CITY OF ALBUQUERQUE

March 4, 2019

RE: **1st Nations Community Healthsource Bldg C Addition**
5608 Zuni SE
Revised Grading and Drainage Plan
Engineers Stamp Date: 2/21/19
Drainage File: L18D047A

Based on the submittal received on 2/25/19, the Grading and Drainage Plan cannot be approved until the following are corrected:

C-002

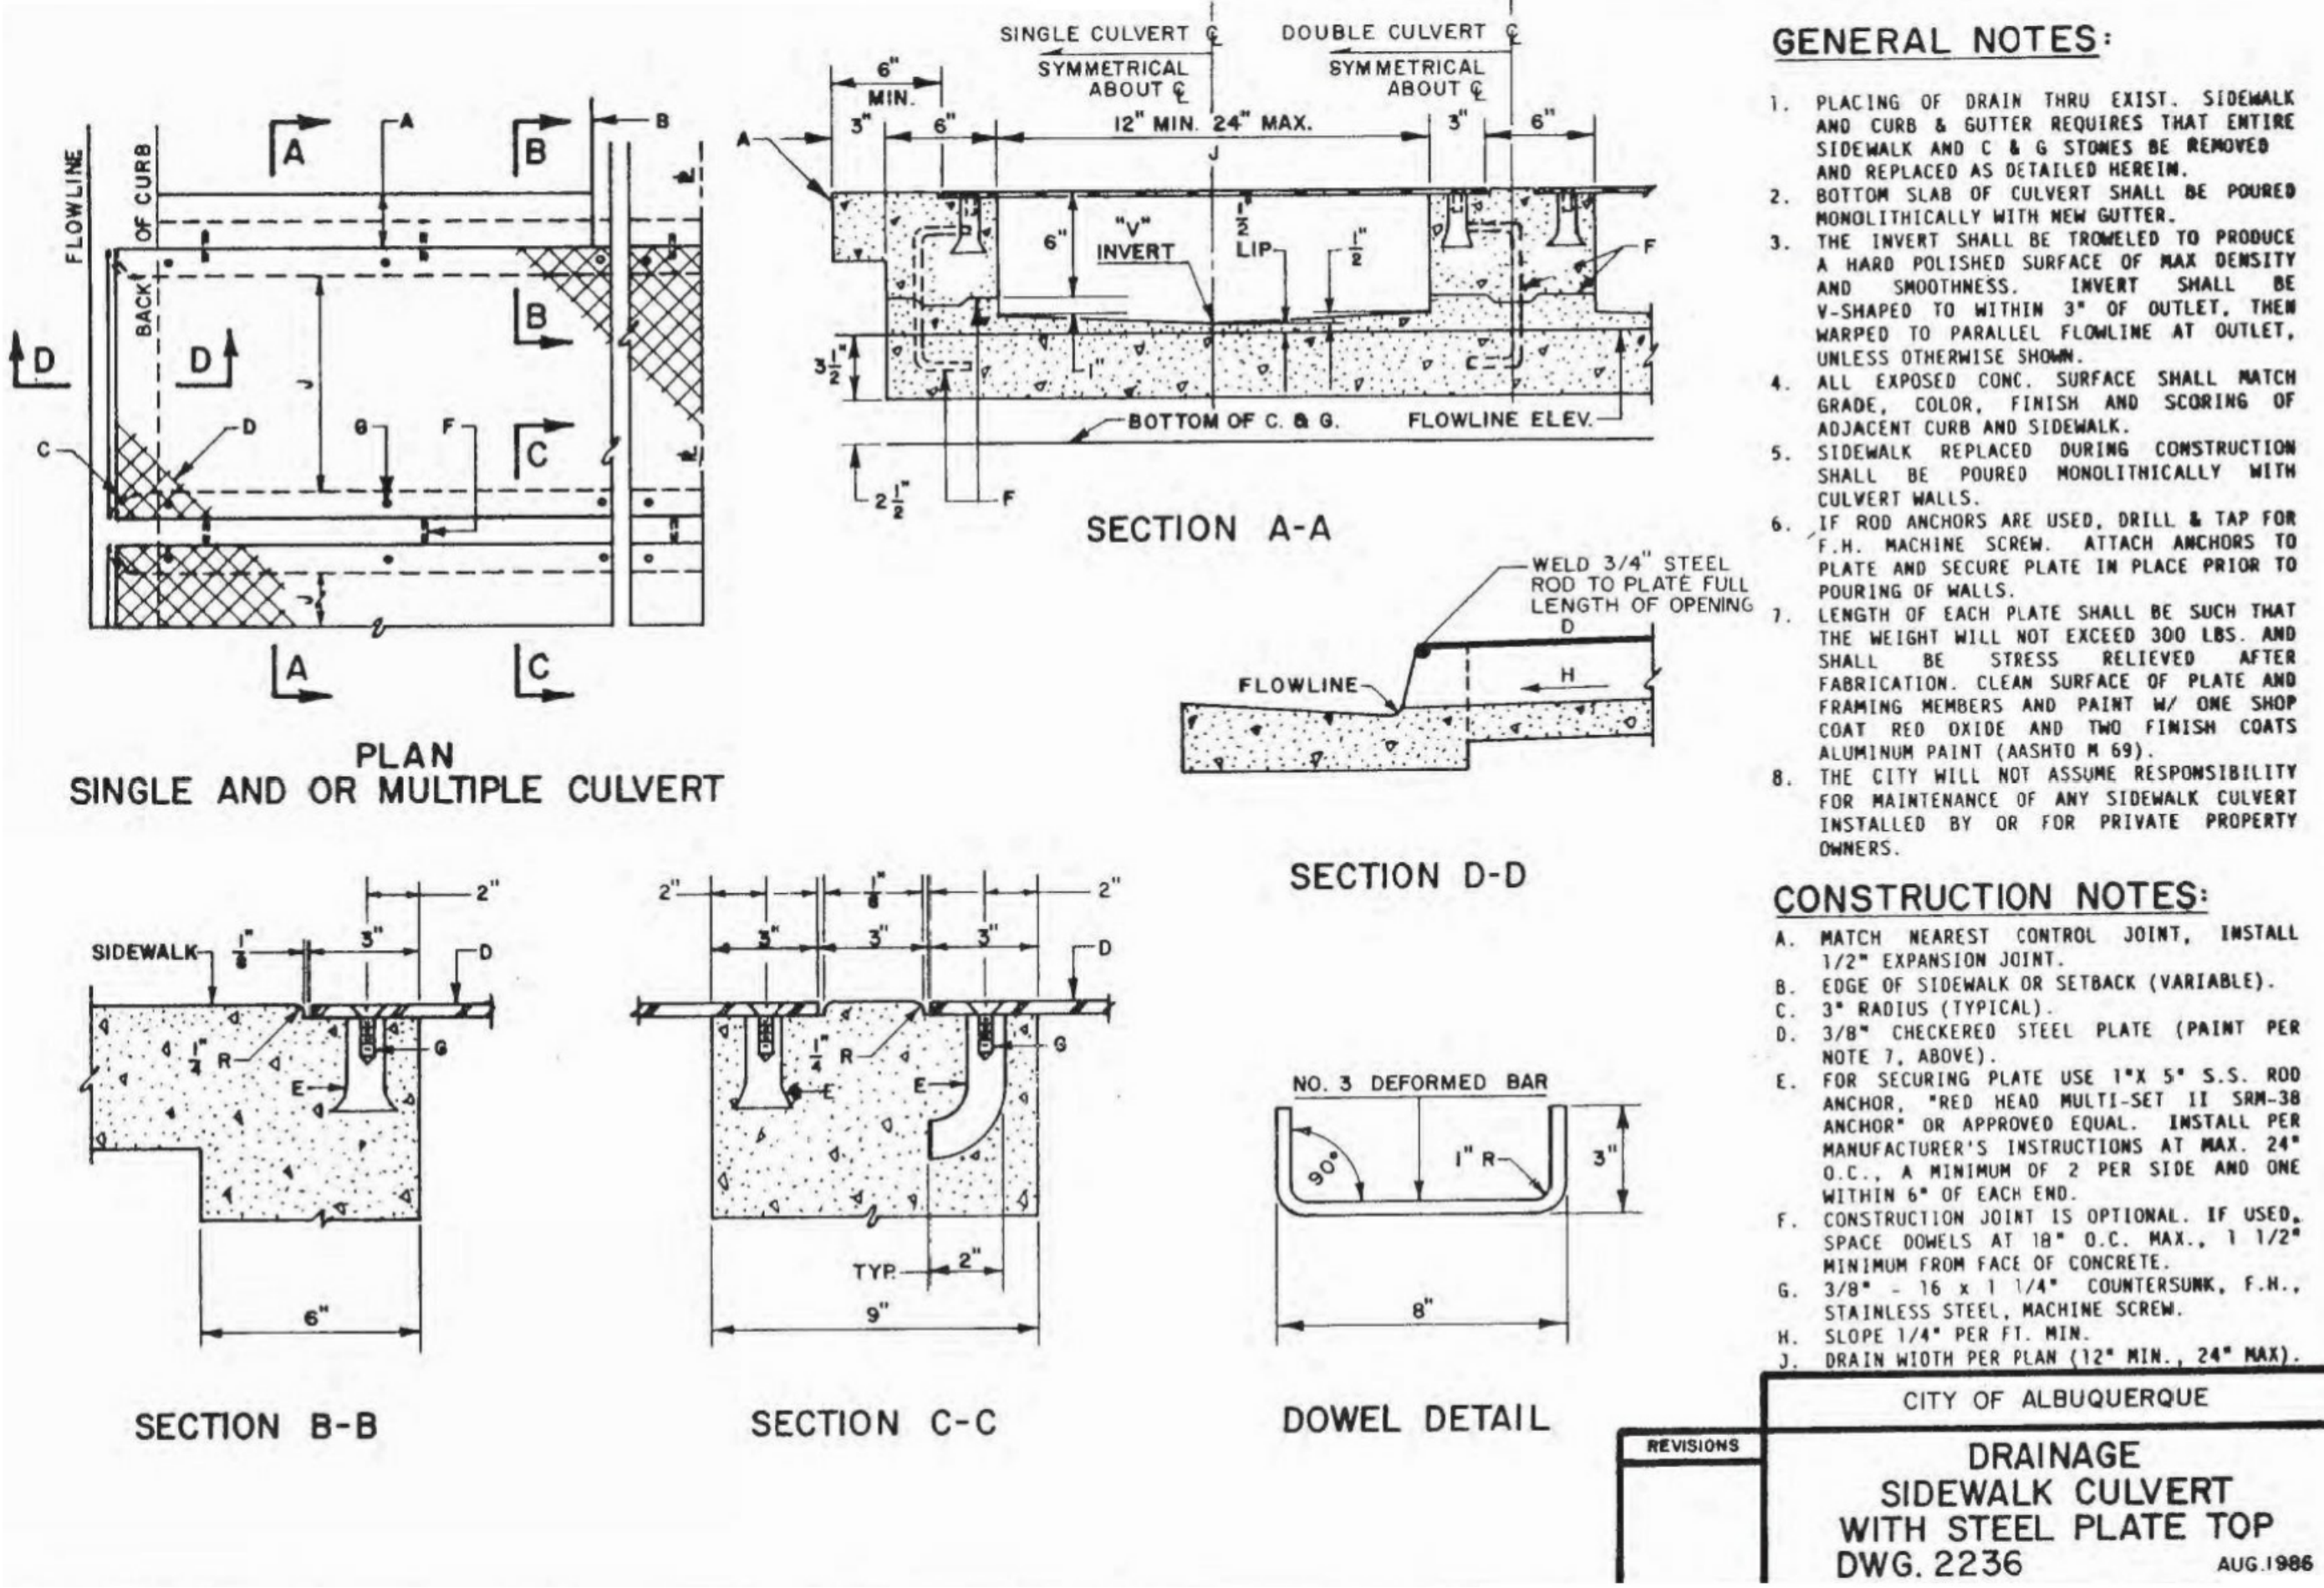
1. The plan needs to clearly state: that the applicant could provide on-site management of the storm water quality volume (SWQV), that the applicant does not wish to provide on-site management, and is requesting to pay a fee-in-lieu of onsite management instead. This site could easily provide onsite retention by relocating utilities to accommodate a pond, by locating the pond under the parking lot (underground storage) or grading the parking lot to drain to another location where utility conflicts do not exist.
2. Payment of the Fee in Lieu (Amount = $207\text{CF} \times \$8/\text{CF} = \1656 , per sheet C-002) of onsite management of the SWQV must be made. Include a copy of the paid receipt when resubmitting.
3. An SO-19 Permit will be required; please include the [standard SO-19](#) notes on the grading plan.

4. Engineer's Certification, per the DPM Chapter 22.7: *Engineer's Certification Checklist For Non-Subdivision* is required.
5. The sidewalk culverts must be inspected and approved by storm drain maintenance (Jason Rodriguez, jtrodriguez@cabq.gov or 857-8607).

- A. DUE TO THE PROXIMITY OF THE EXISTING RIGHT OF WAY, A FEE IN LIEU OF STORM WATER QUALITY VOLUME (SWQV) MUST BE USED TO ACCOMMODATE THE FIRST FLUSH REQUIREMENT.

1. PROVIDE 24 "X 6" CONCRETE CULVERT INSTALL SIDE WALK CROSSING PER DETAIL THIS SHEET. NOTE: SO 19 PERMIT MUST PULLED BY INSTALLING CONTRACTOR. AN EXCAVATION/ BARRICADING PERMIT IS ALSO NEEDED. SIDEWALK CULVERTS MUST APPROVED BY STORM DRAIN MAINTENANCE (JASON RODRIGUEZ, jrodriguez@cabq.gov OR 505-857-8607.
